**RM03**

DISK DRIVE

PROCESSOR TYPE 10, 11, VAX

Engineering Change  
Order Log

FIGURE 1

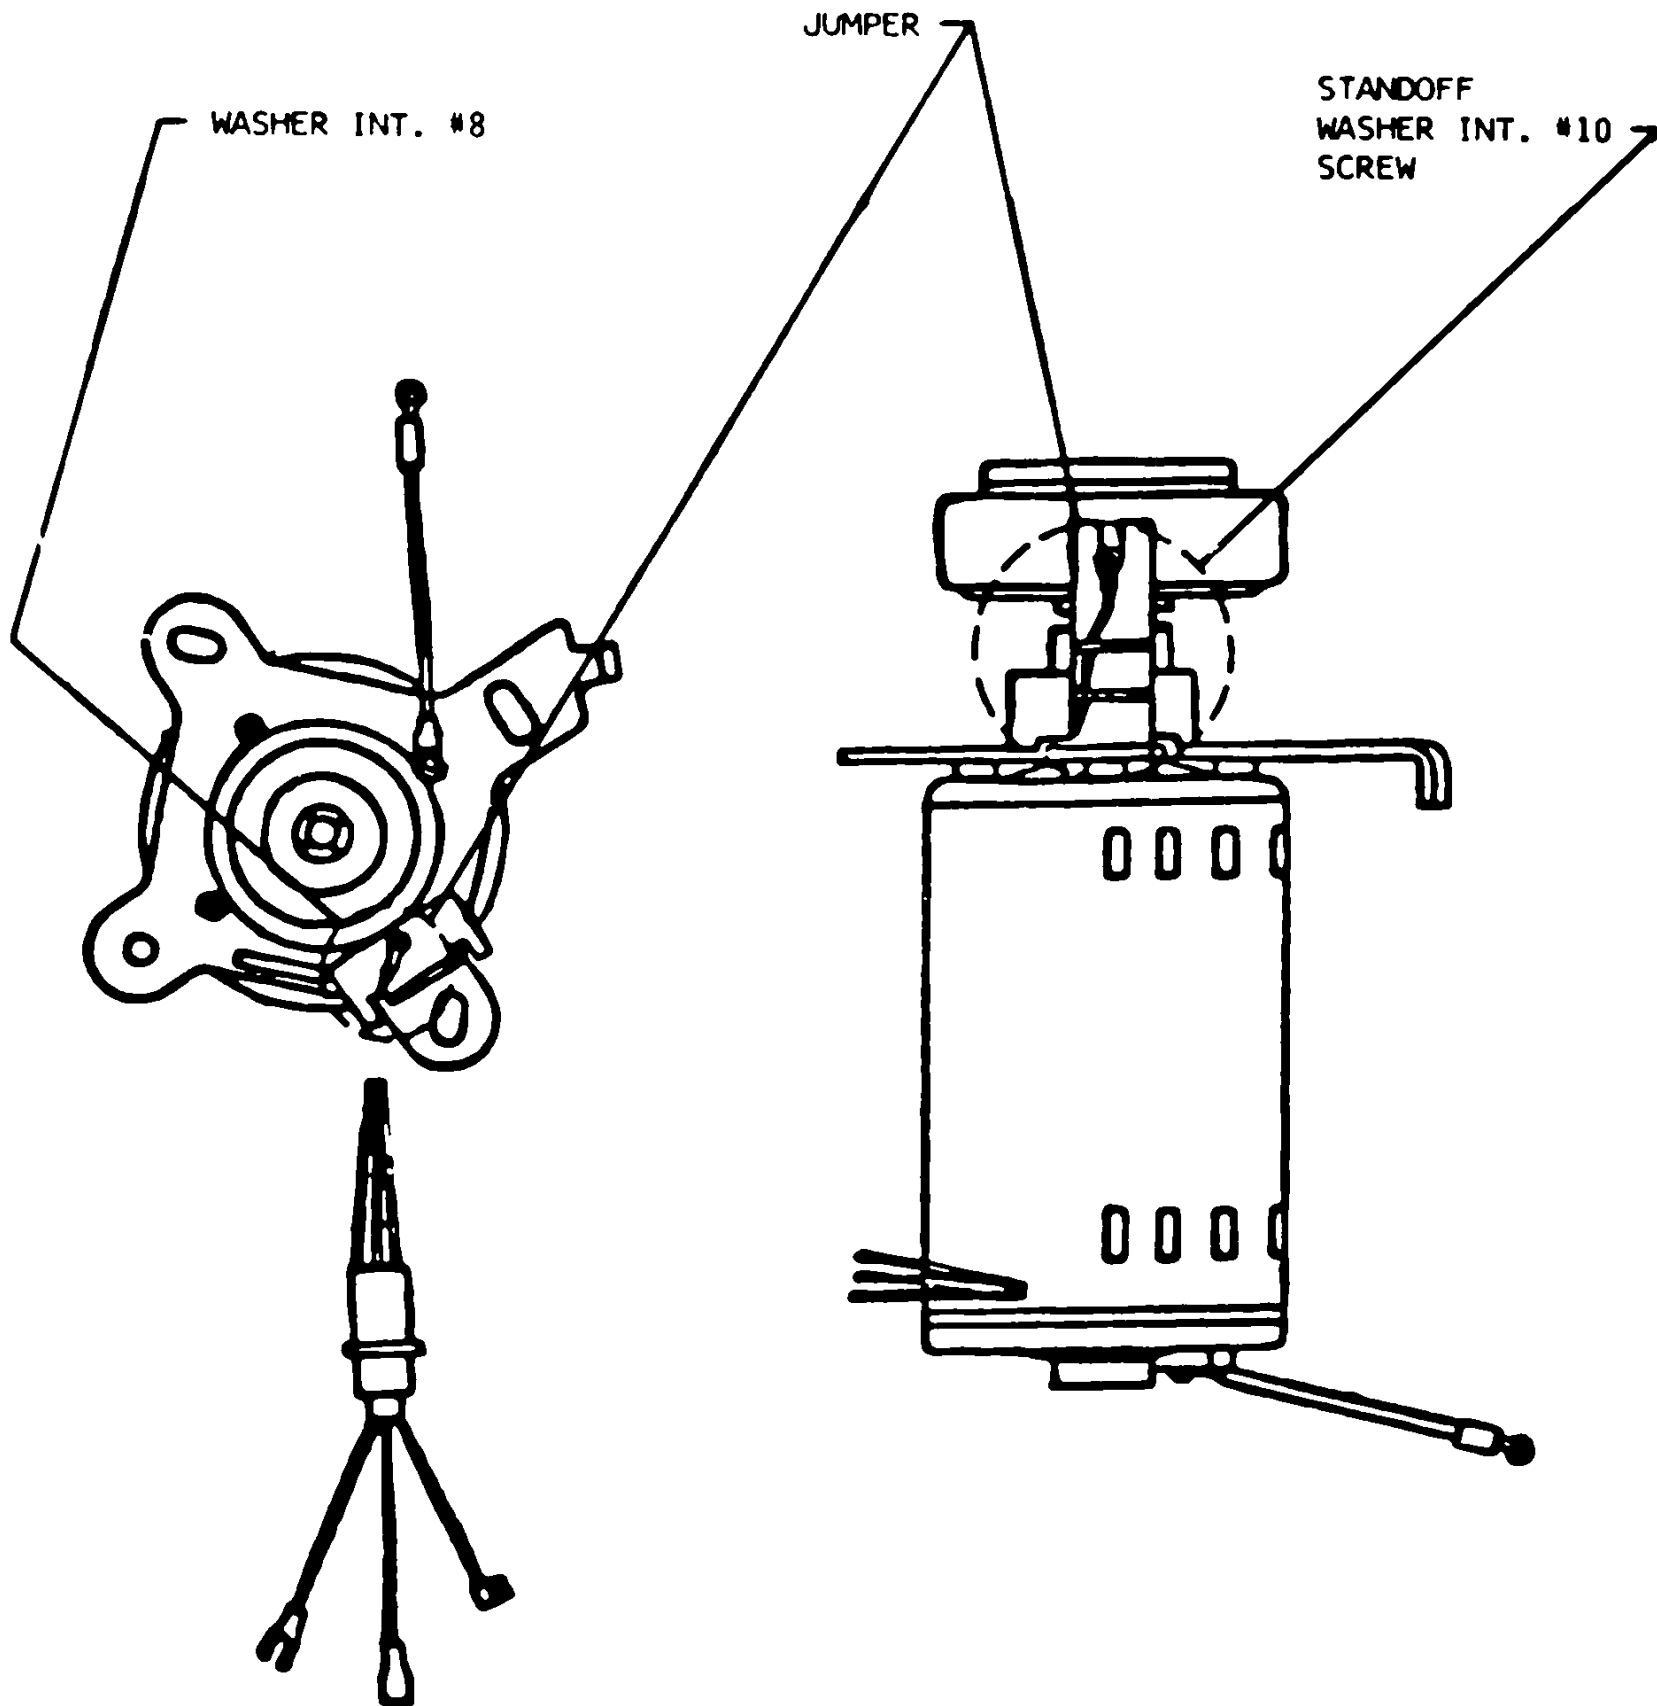
SEP 81 - PROBLEM SYMPTOM. Intermittent data checks (DCK)  
PROBLEM Ungrounded brake assembly is source of intermittent read errors.  
CORRECTION Add grounding to brake assembly.  
IN-PLANT EFFECTIVITY (February, 1981) Immediately into drives with serial number 45,300 or above.  
FIELD EFFECTIVITY Retrofit all RM03 drives, series 29 and 36, when problem symptom is evident.  
QUICK CHECK. Presence of ground jumper wire from brake assembly to drive motor mounting plate

- 6- REMOVE TWO (2) SCREWS IN PACK WELL AND RAISE TOP DECK TO MAINTENANCE POSITION.
- 7- LOCK MAINTENANCE BRACKET IN PLACE WITH THUMB SCREW .
- 8- INSTALL ONE END OF GROUND JUMPER (CDC 77579946) ON DRIVE MOTOR MOUNTING PLATE USING EXISTING SCREW AND WASHER INT. #8 (CDC 10126104). (FIGURE 1)

- 9- INSTALL OTHER END OF GROUND JUMPER ASSEMBLY ON BRAKE ASSEMBLY STANDOFF USING WASHER INT. #10 (CDC 10126105), STANDOFF (CDC 73078800), AND SCREW PAN HD. (CDC 10127361). (FIGURE 1)

FIGURE 1  
POWER SUPPLY BOARD 5VQN

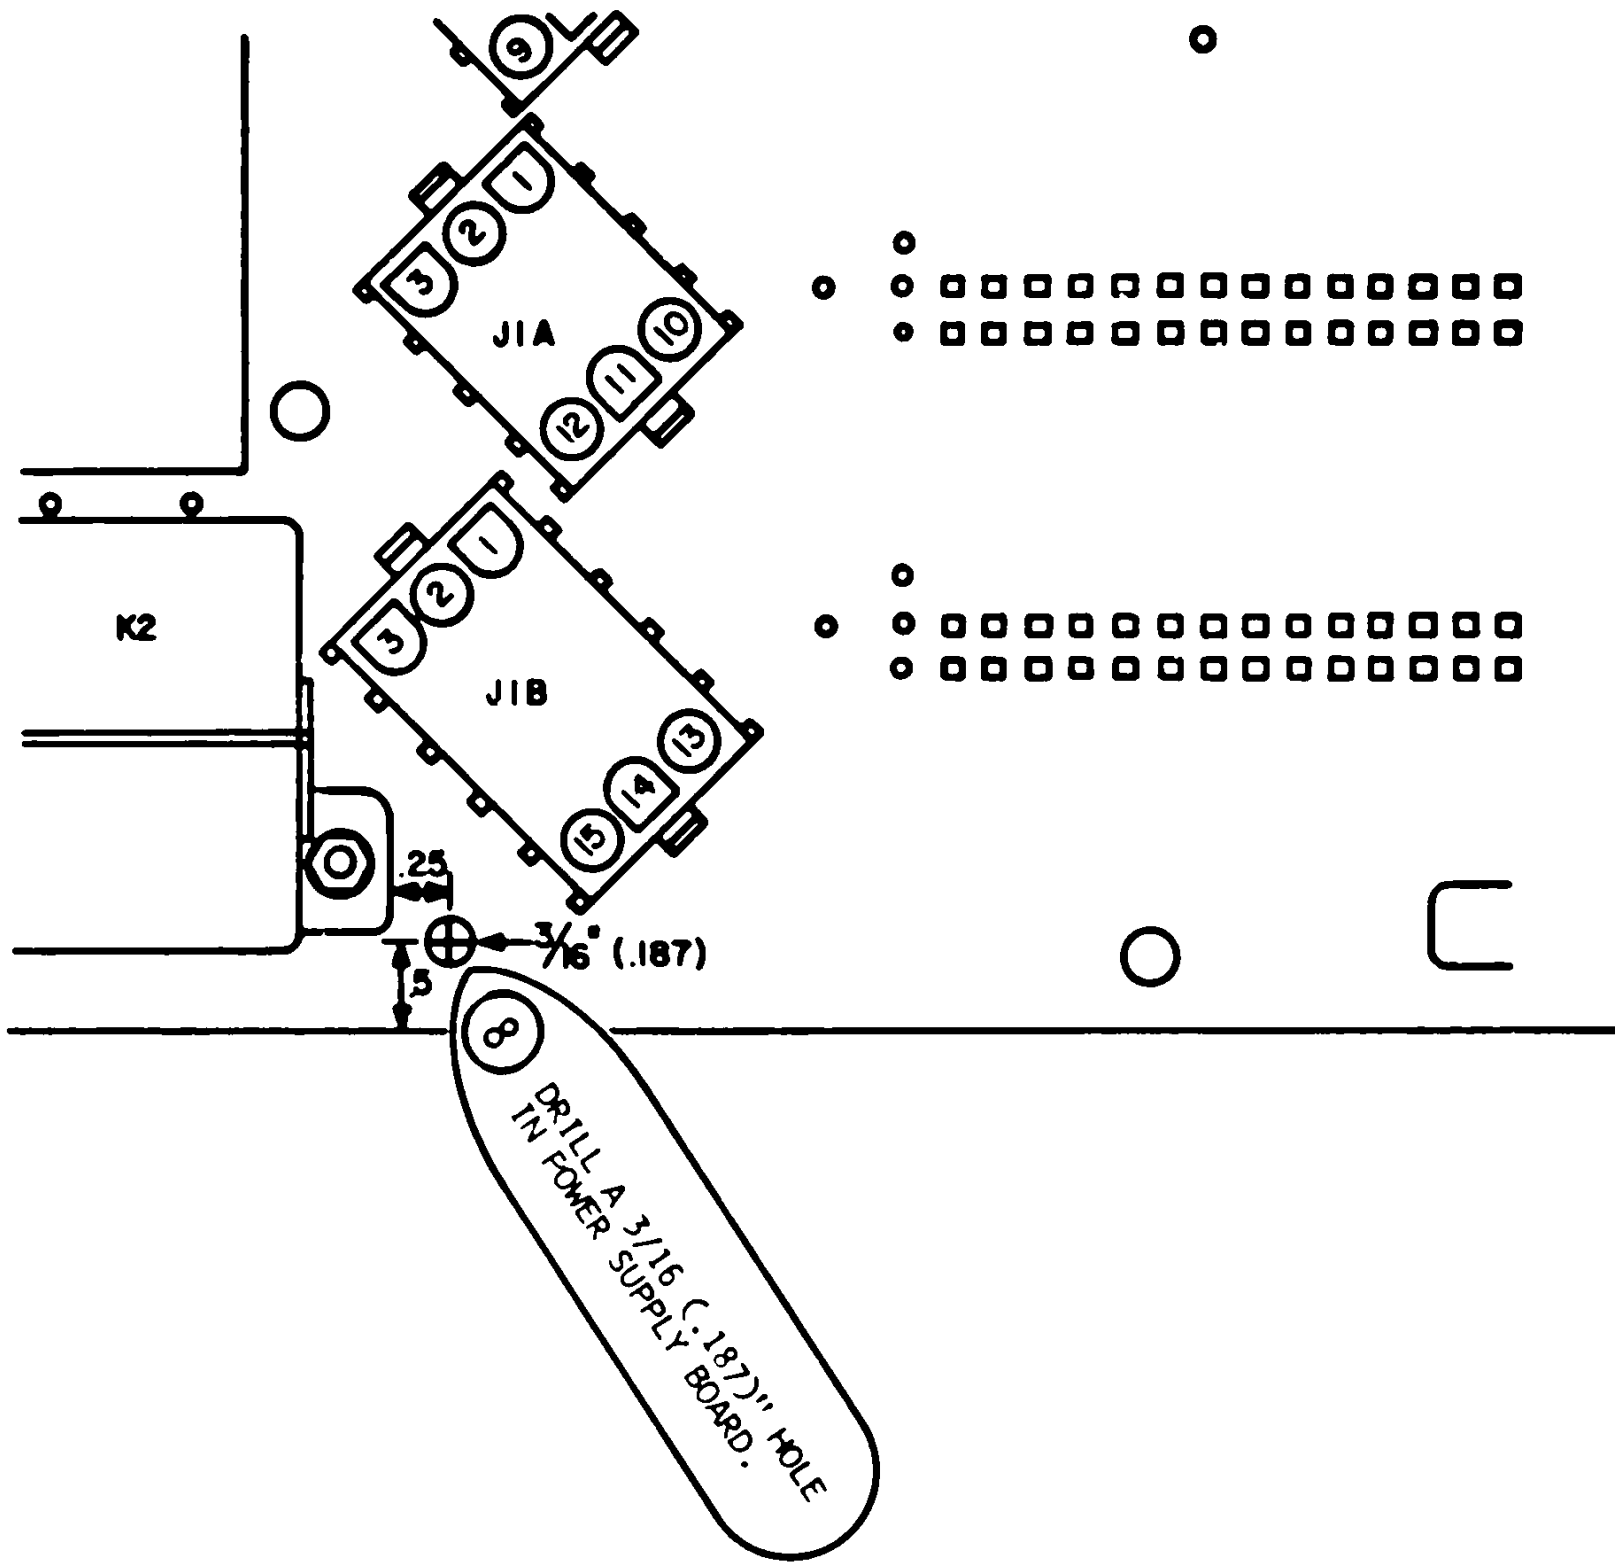
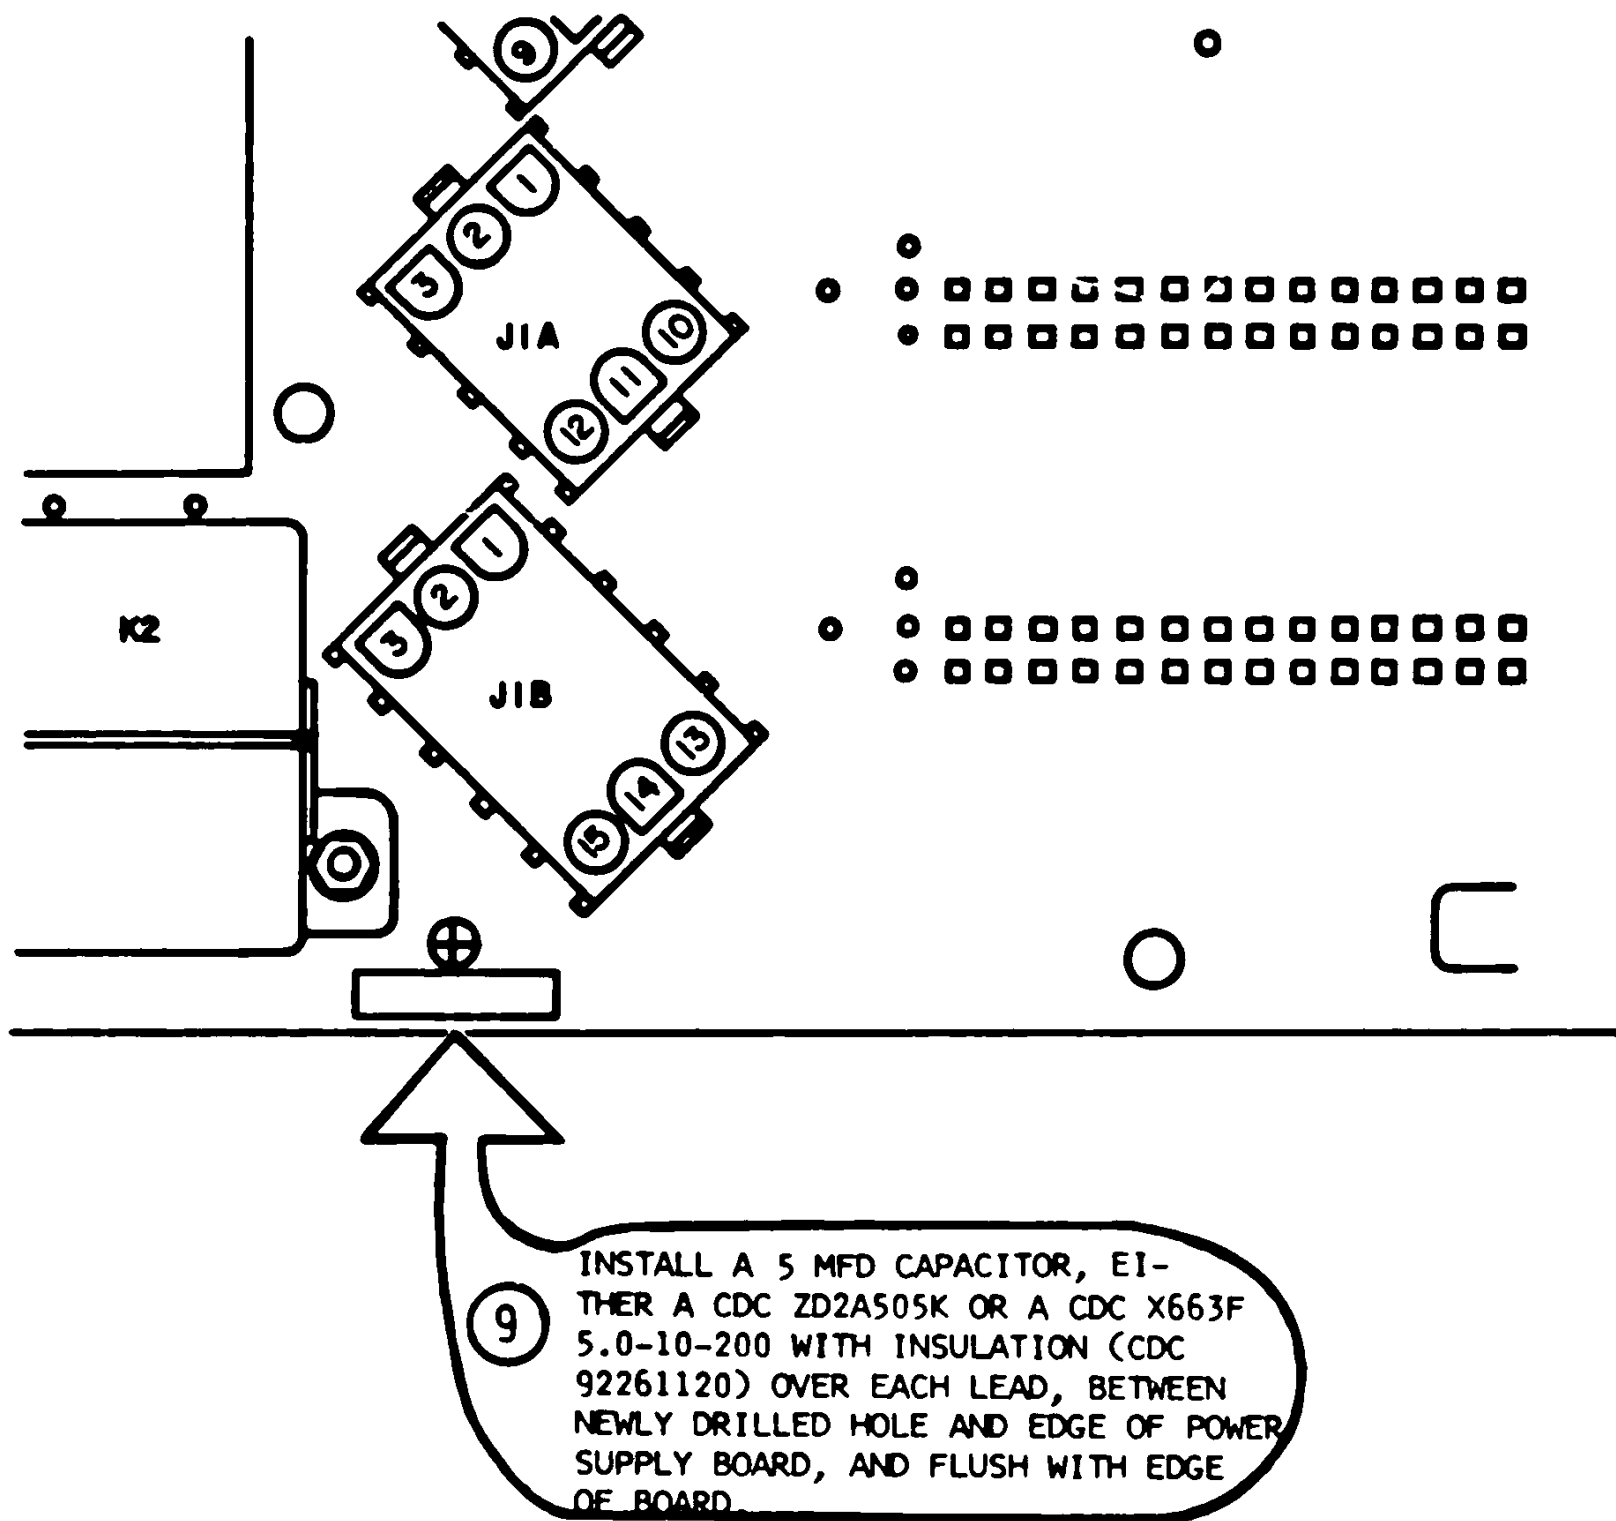
JAN 83 - PROBLEM SYMPTOM: Excessive data check or header CRC errors.  
PROBLEM: Arcing contacts on A1K2 emergency retract relay  
CORRECTION. Rework Power Supply Board 5VQN per vendor ECO, CDC NEC J296.  
IN-PLANT EFFECTIVITY: (April, 1982) Immediately  
FIELD EFFECTIVITY. Retrofit all RM03 drives series code 43 and below when problem symptoms are evident..  
QUICK CHECK. Presence of 5.0 MFD capacitor mounted on underside of Mother Board. (Use flashlight and inspection mirror to determine presence of capacitor.)

- 4- DISCONNECT CONNECTORS PIB, PIA, AND P100 FROM POWER SUPPLY BOARD 5VQN.
- 5- REMOVE THREE POWER SUPPLY CARDS.
- 6- REMOVE AND RETAIN SEVEN 6-32 BY 5/6 PHILLIPS HEAD SCREWS SECURING POWER SUPPLY BOARD 5VQN TO STANDOFFS.
- 7- REMOVE POWER SUPPLY BOARD.
- 8- DRILL A 3/16 (.187)" HOLE IN POWER SUPPLY BOARD. (FIGURE 1)
- 9- INSTALL A 5 MFD CAPACITOR, EITHER A CDC ZD2A505K OR A CDC X663F 5.0-10-200 WITH INSULATION (CDC 92261120) OVER EACH LEAD, BETWEEN NEWLY DRILLED HOLE AND EDGE OF POWER SUPPLY BOARD, AND FLUSH WITH EDGE OF BOARD. (FIGURE 2)
- 10- SOLDER ONE LEAD OF CAPACITOR TO PIN 8 OF RELAY K2.
- 11- SOLDER OTHER LEAD OF CAPACITOR TO PIN 6 OF PLUG J1.
- 12- ENSURE CAPACITOR IS FLUSH WITH EDGE OF POWER SUPPLY BOARD AND USE TIE WRAP (CDC 94277401) TO SECURE CAPACITOR TO BOARD.

Figure 2 Start Triac A3K5

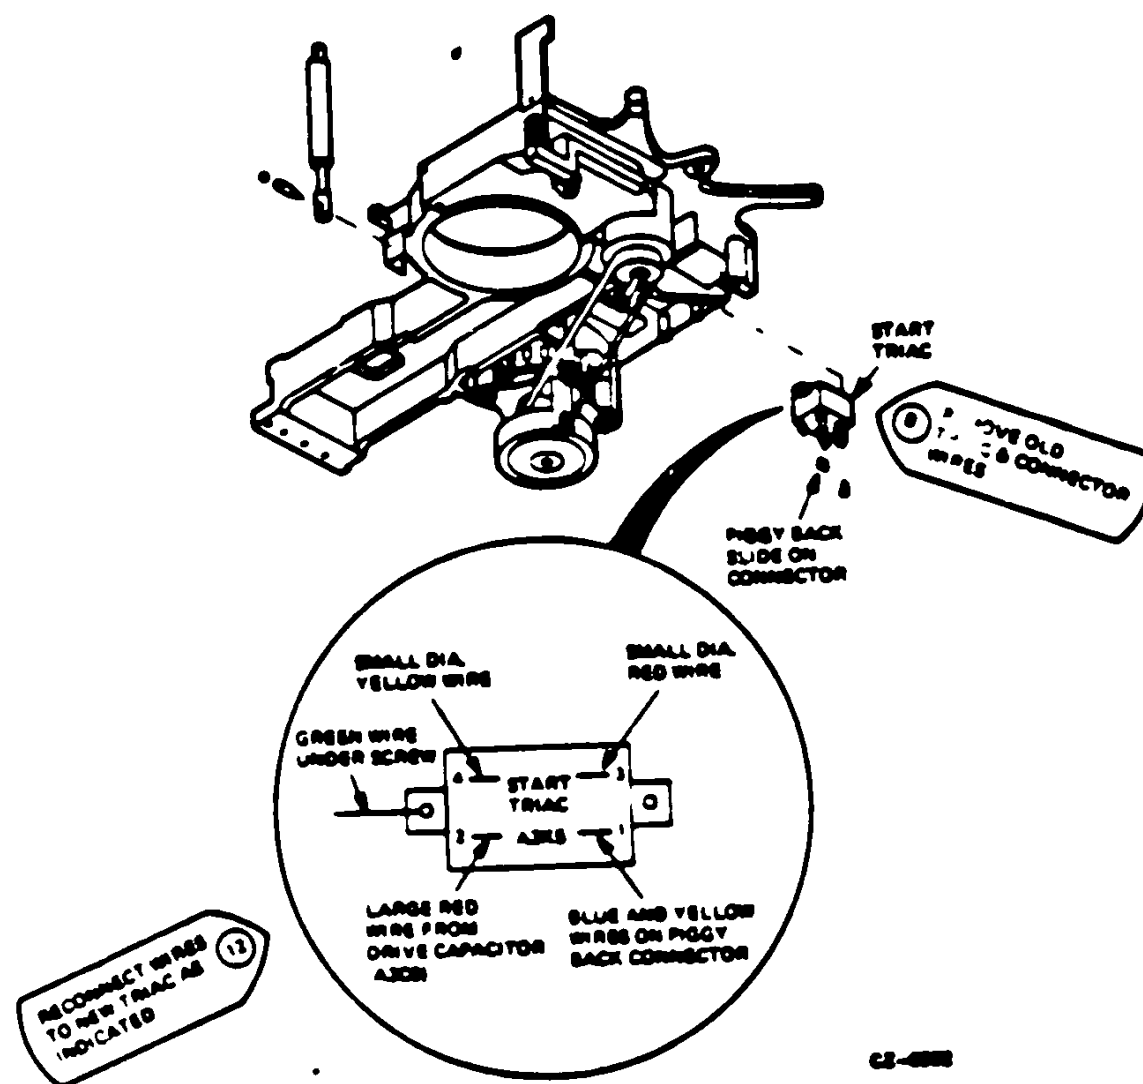
**RM03-S0030 CODE: F**  
MAY 84 - PROBLEM Possible start relay failure due to the peak inverse voltages in the excess of the device rating.  
CORRECTION. Replace the 600 volt start relay (A3K5) with the 800 volt start relay per CDC NEC #J255  
IN-PLANT EFFECTIVITY: Aug 82  
FIELD EFFECTIVITY: Retrofit all RM03 drives, series 42 and below when the Problem/Symptom is evident.  
QUICK CHECK. CDC P/N 94378603 is stamped on the relay at location A3K5 in the RM03 drive.

- 
9. Remove the two (2) screws that secure the triac in place.
  10. Apply a light coat of dielectric grease to the base of the new triac.
  11. Mount the new triac using the two (2) screws previously removed. Be sure to attach the green grounding wire to one of these screws.
  12. Reconnect all wires to the triac terminals according to Figure 2.
  13. Release the deck support bracket and lower the deck into the operating position.
  14. Re-install the two (2) deck hold-down screws inside the pack shroud area.
  15. Remove the rear hold-down spacer and install it in the keeper hole.
  16. Restore the head actuator holding pin to its "storage" hole.
  17. Replace the top cover onto the Drive.
